REMARKS

Serial No. 10/813,169
Reply to Office Action dated April 22, 2005

Docket No. INTEL-0062

FIG. 2

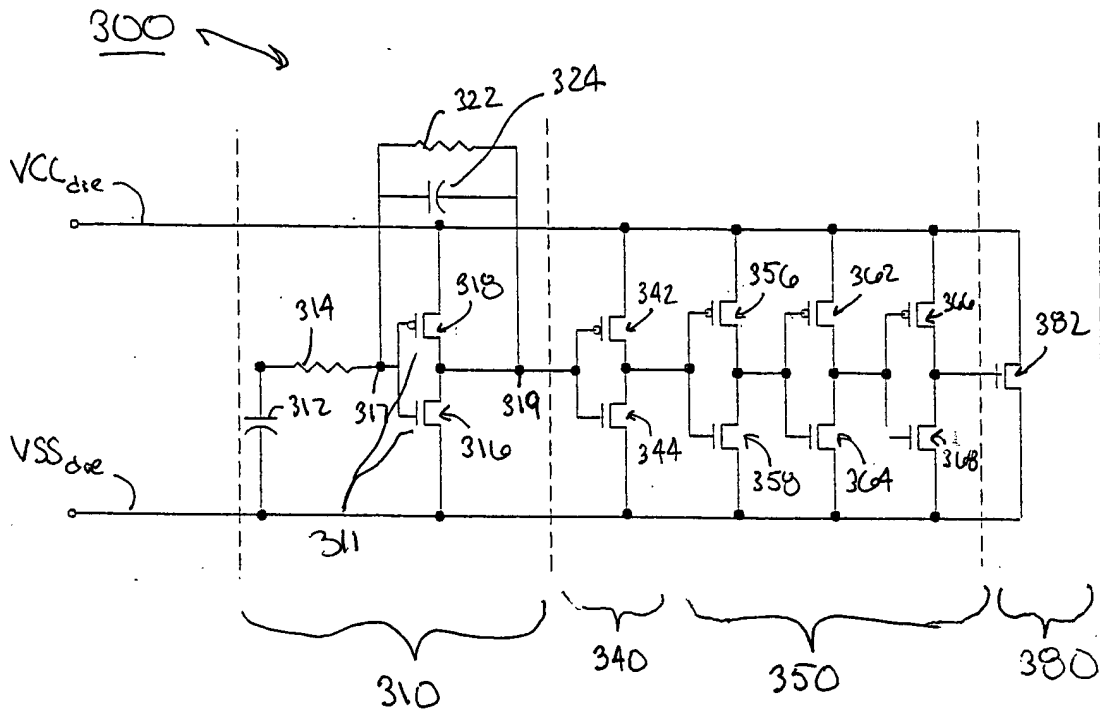
The Office Action questions how the recitation of “the band-pass filter including an operational amplifier and a comparator portion is read on the preferred embodiment.” Applicants respectfully submit that at least Figure 2 includes a band-pass filter 310 having an operational amplifier that may include transistors 316 and 318. See, for example, page 7, lines 14-16 of the present application. In order to further prosecution, this sentence is amended to label element 311 as the operational amplifier. Figure 2 is also amended to label the operational amplifier 311. No new matter is added.

The attached drawings include changes to Figs. 1-3. These sheets replace the original sheets. Each of replacement Figs. 1-3 is a formal drawing of the original drawings. In Figure 2, element 311 has been labeled. The specification has also been revised to correspond to this change.
